ARCHITECTURAL REVIEW BOARD MEETING

PROJECT COMMENTS

PROJECT NUMBER: SP2023-005
PROJECT NAME: Site Plan for the Pregnancy Resource Center
SITE ADDRESS/LOCATIONS: 1010 RIDGE RD

PROJECT NUMBER: SP2023-006
PROJECT NAME: Amended Site Plan for Stream
SITE ADDRESS/LOCATIONS: 1351 CORPORATE CROSSING

RIDGE ROAD VILLAGE
CAB. A, SLIDE 35
P.R.R.C.T.

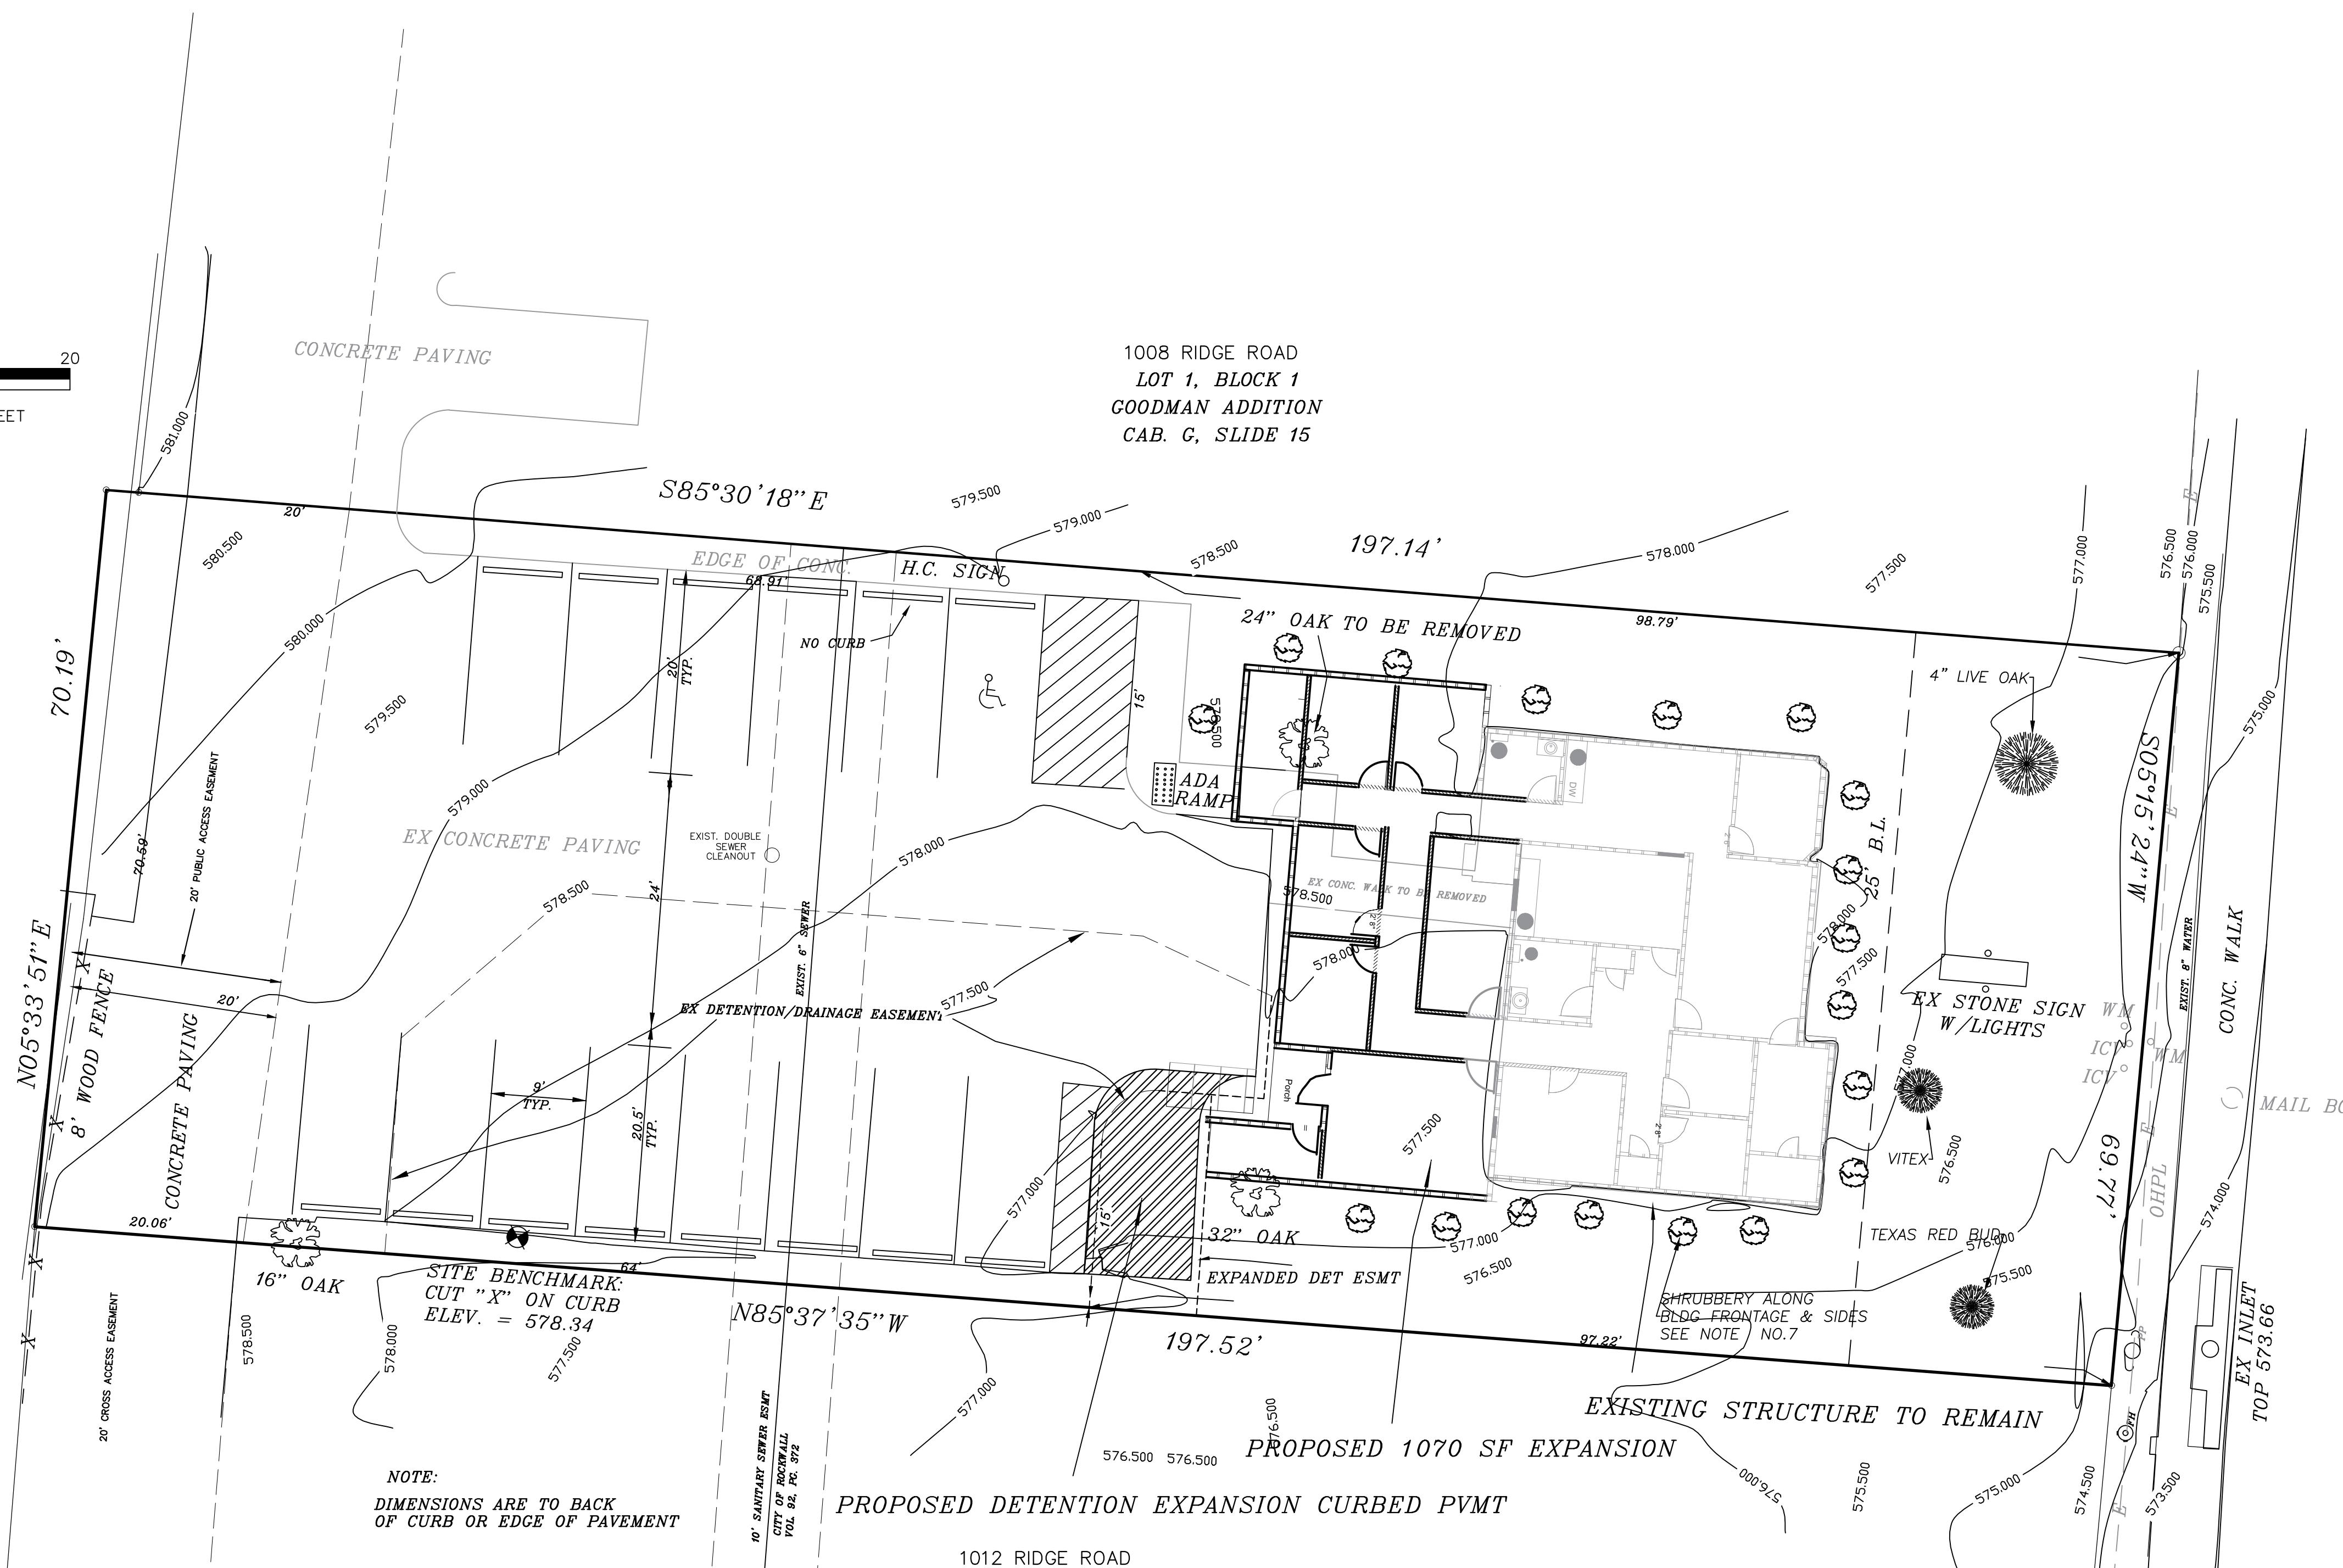
- (2) Please provide exhibits of all proposed and/or existing fencing. (Subsection 08.02, F. of Article 08)
- (3) All ground mounted utility equipment shall be screened with 5-gallon evergreen shrubs. (Subsection 01.05, C. of Article 05)

- (4) Indicate the landscape buffer. (Subsection 05.01, of Article 08)
- (5) Vitex is not an approved plant within the landscape buffer. (Appendix C)
- (6) All shrubs shall be a 5-gallon minimum. (Appendix C)

- (8) Please consider shifting the canopy trees back closer to the structure to avoid future issues with the power lines or as an alternative, consider understory trees (see comment M.5.9).

- (9) To satisfy the tree mitigation for the one (1) removed tree, consider planting one (1) additional canopy tree in the front. This would satisfy the balance; you could plant one (1) less accent tree and that would be ok. Also, consider reaching out to our Parks Director, Travis Sales, on canopy tree recommendations that do not have invasive roots and will mitigate future conflicts with the power lines. If the one (1) additional canopy tree is not planted, you will have to request approval of an Alternative Tree Mitigation Agreement from City Council (i.e. to allow you to pay more than 20% of the mitigation balance). (Subsection 03.01, G, of Article 09)

- (10) Please remove note #3, as no new lighting is being proposed.

SHEET NUMBER
T-100

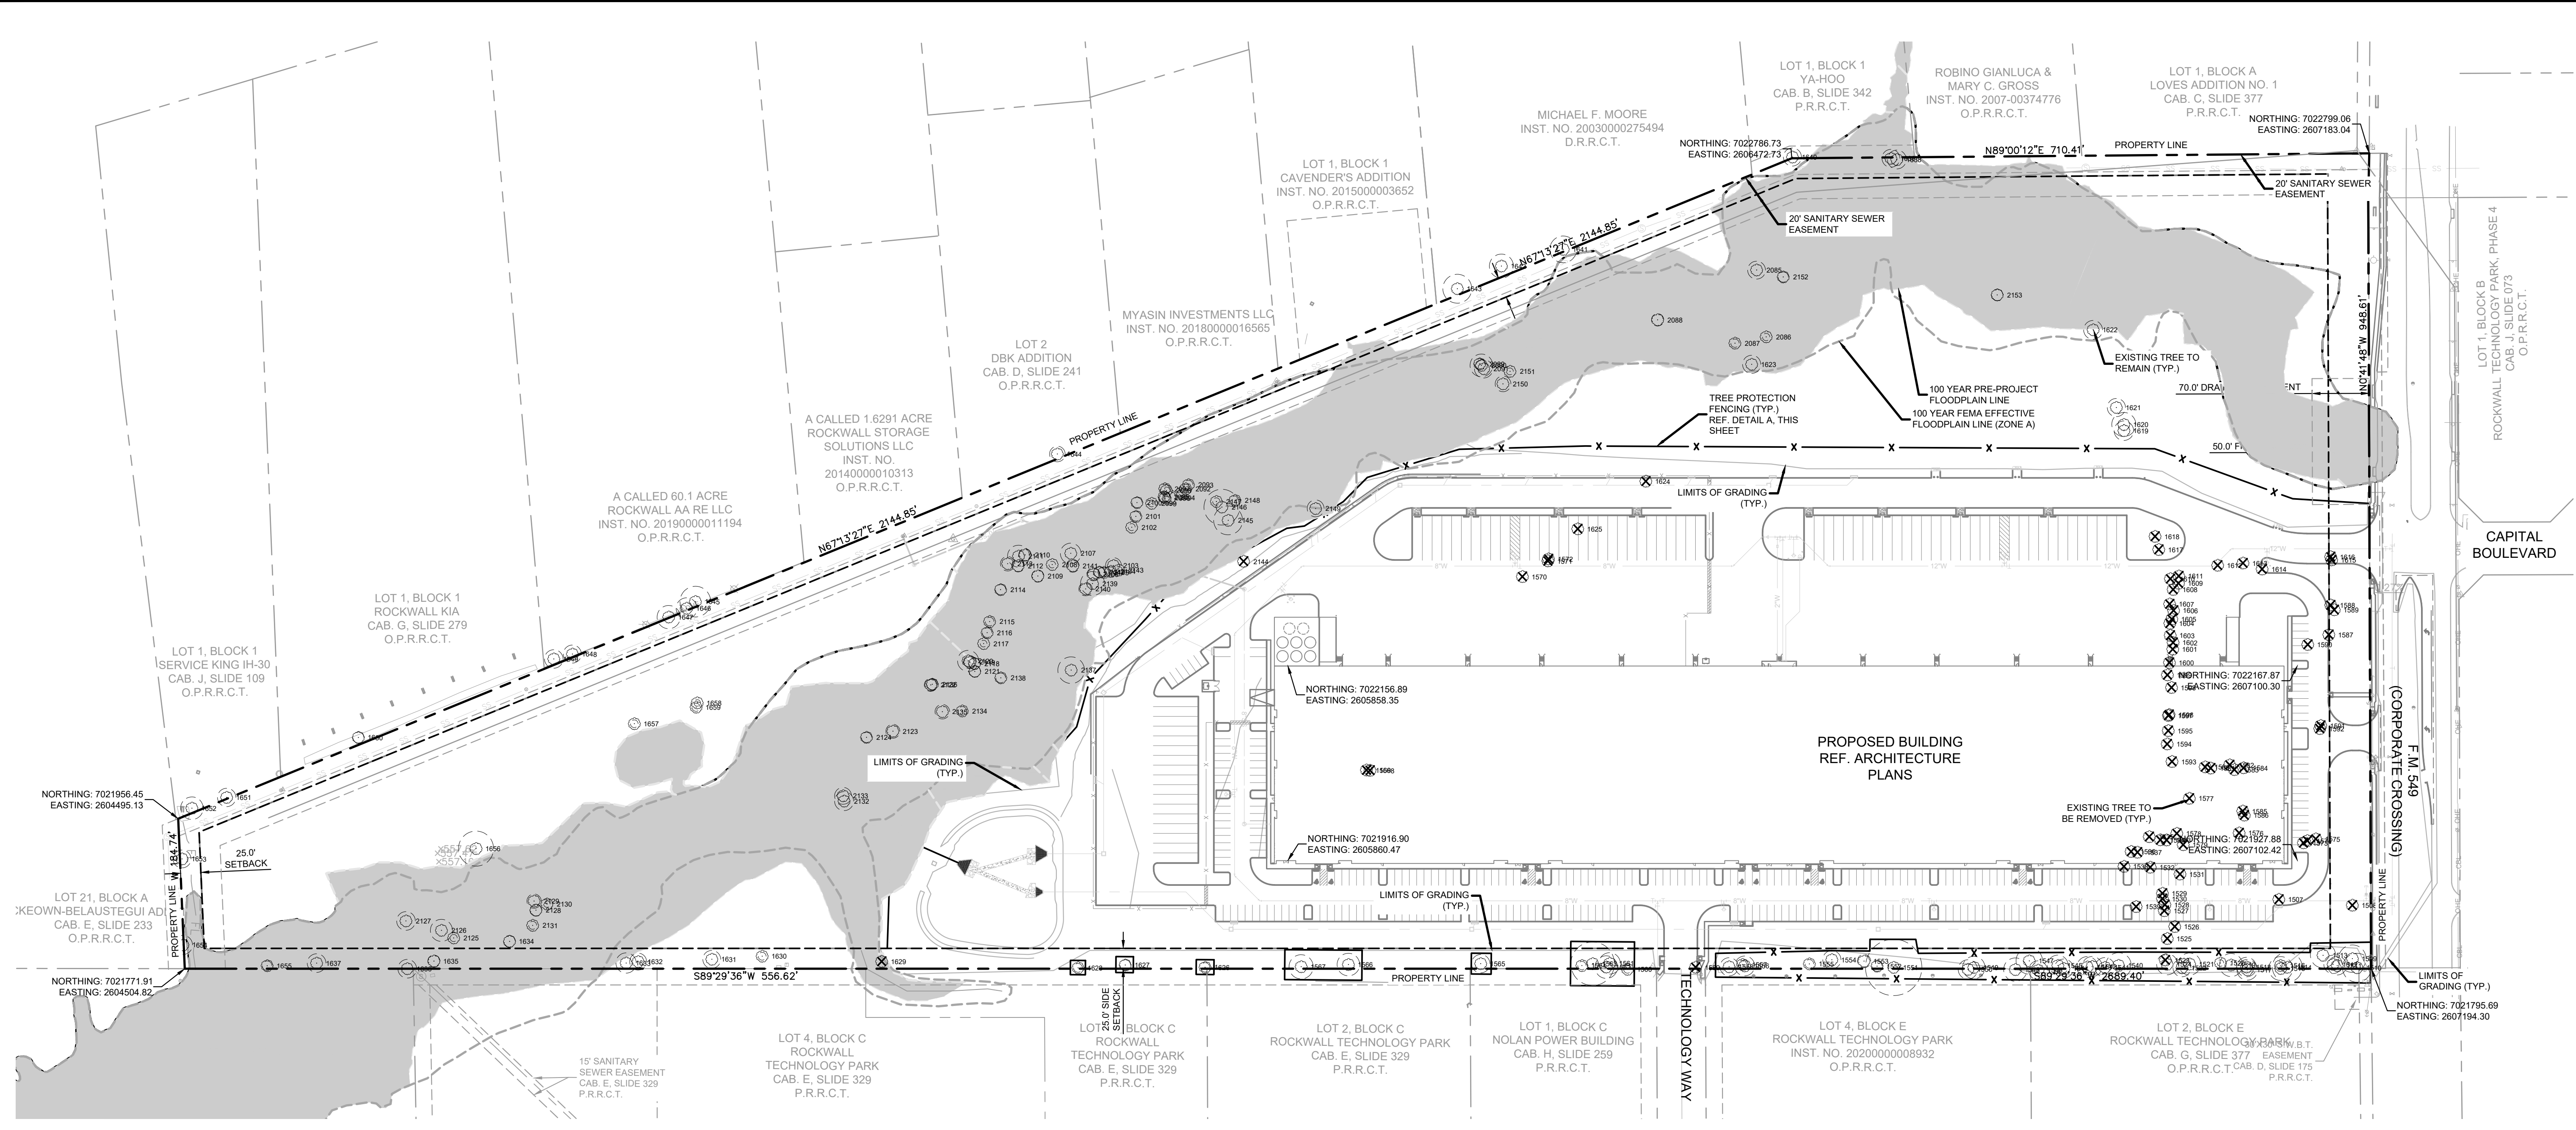
(1) Accent trees do not count towards the mitigation balance. This means that 604-inches are being planted and not 900-inches. That being said, the mitigation balance is still covered. (Subsection 03.01. B, of Article 09)

1 SITE PLAN - PHOTOMETRICS

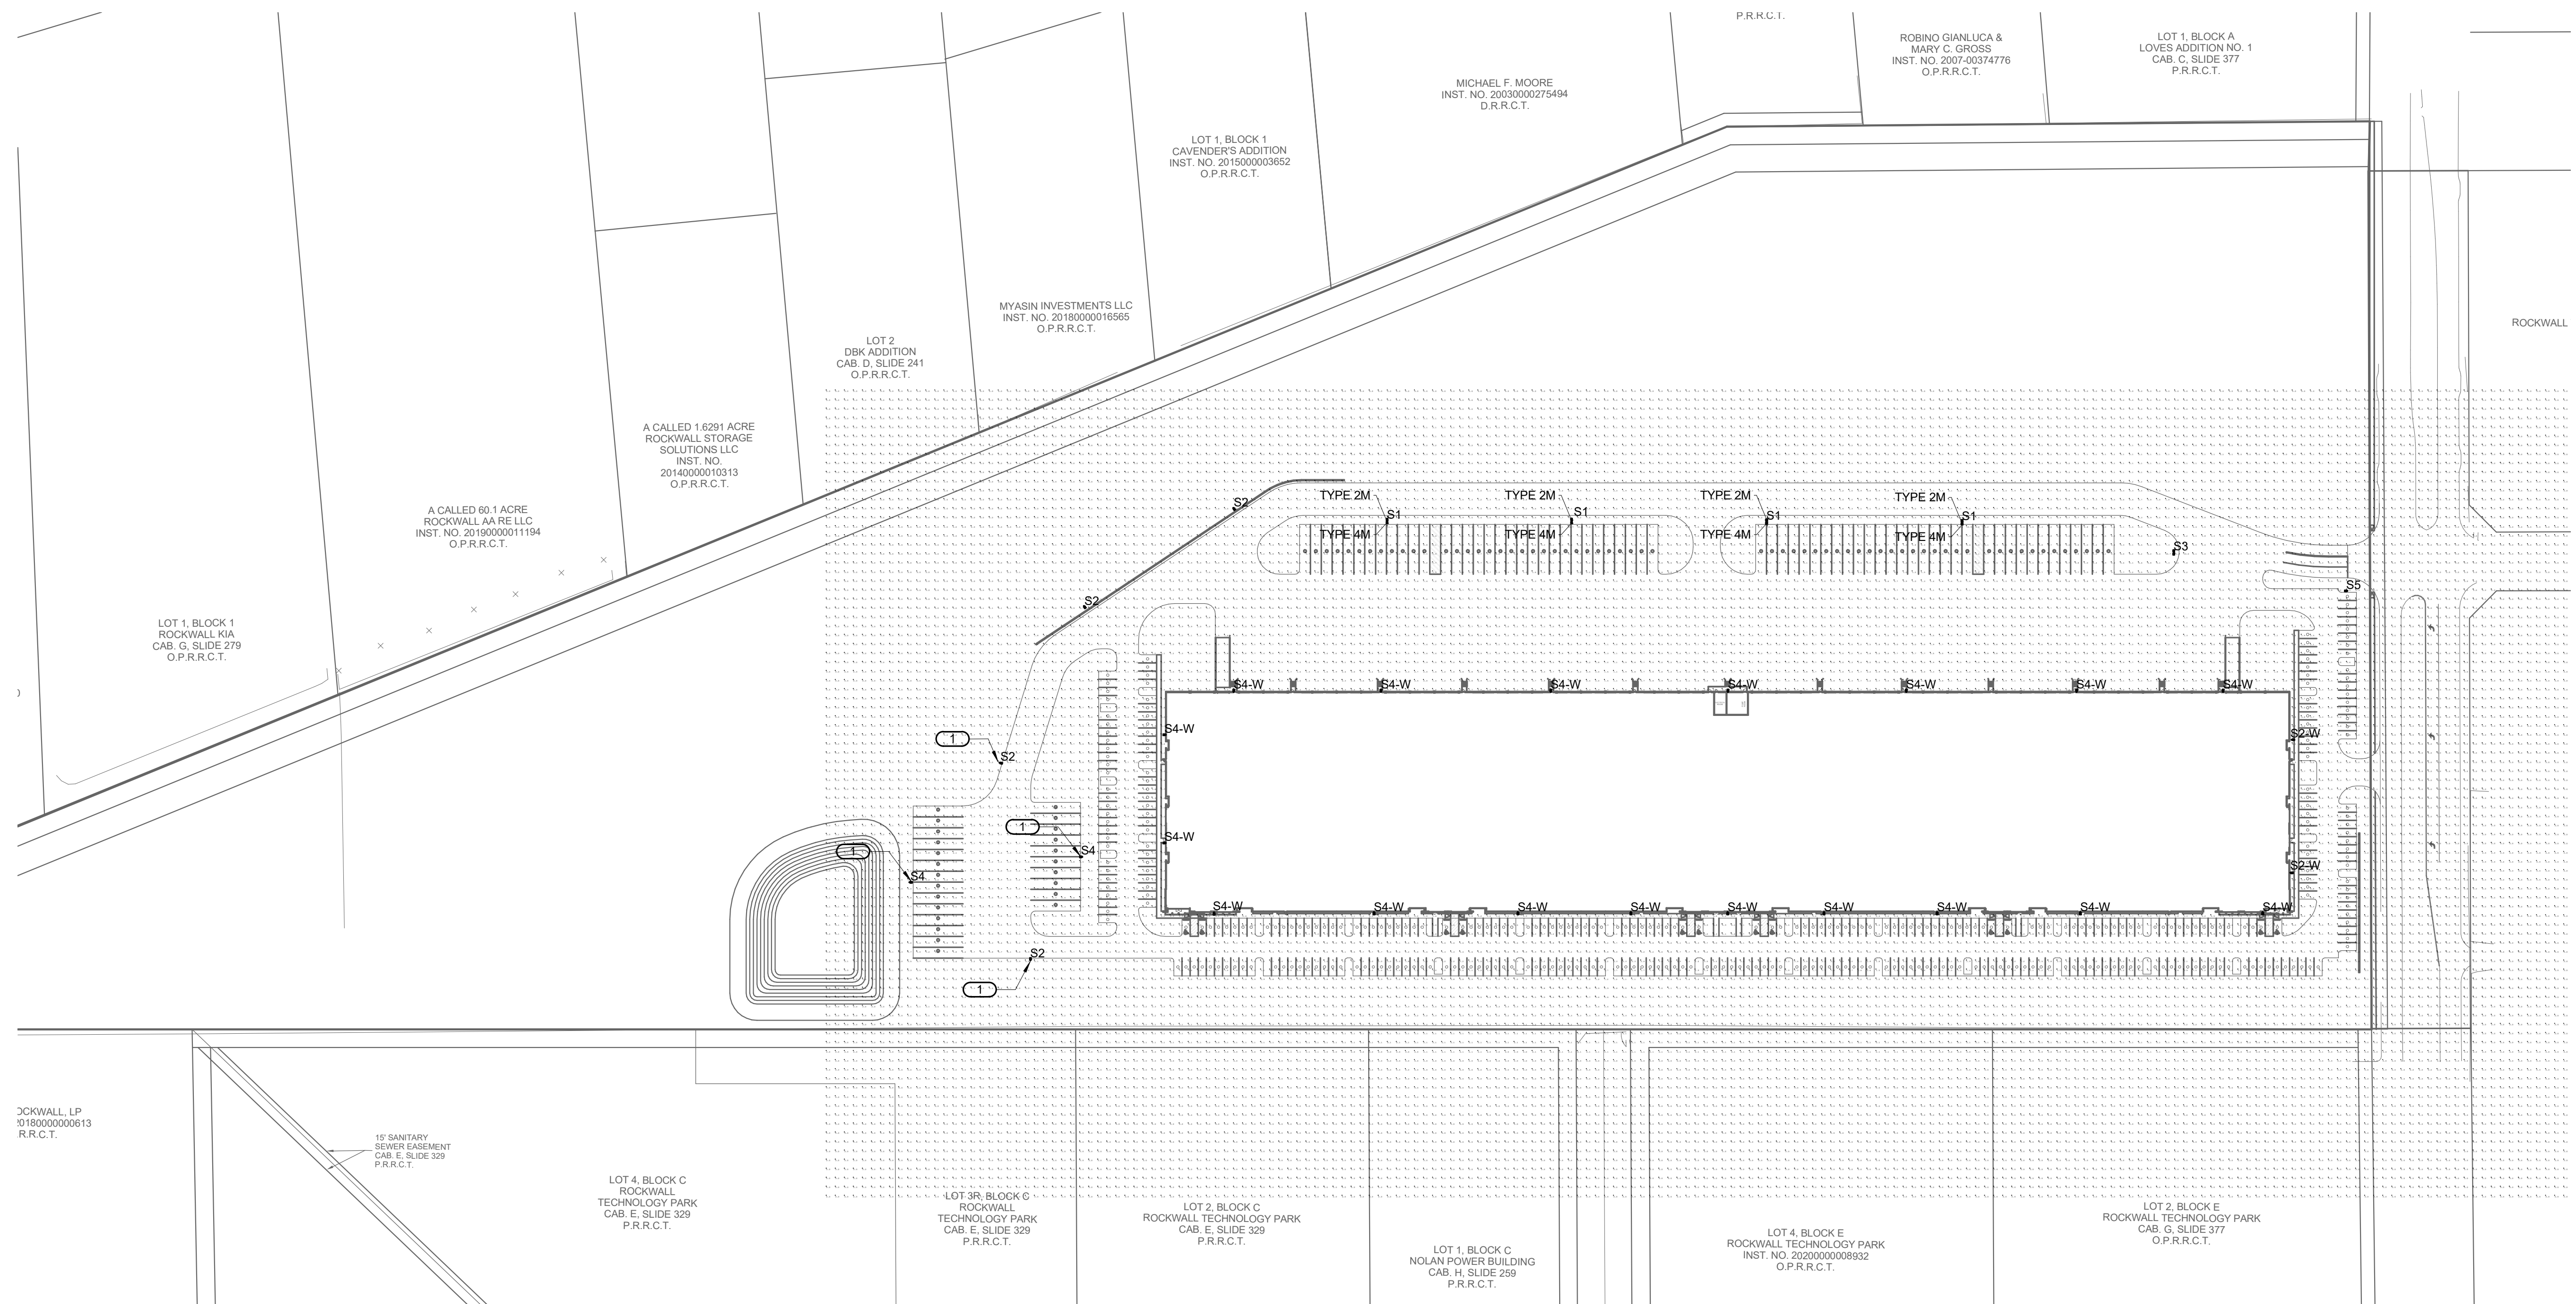
- (1) Provide the site data information required in Section 2.1 of this checklist. (See Section 2.1 of this Checklist)
- (2) All lighting must be mounted at 20-feet or less per the General Overlay District Standards. (Subsection 03.03. D, of Article 07)
- (3) Please provide cutsheets for all of the proposed light fixtures. (Subsection 03.03. A, of Article 07)
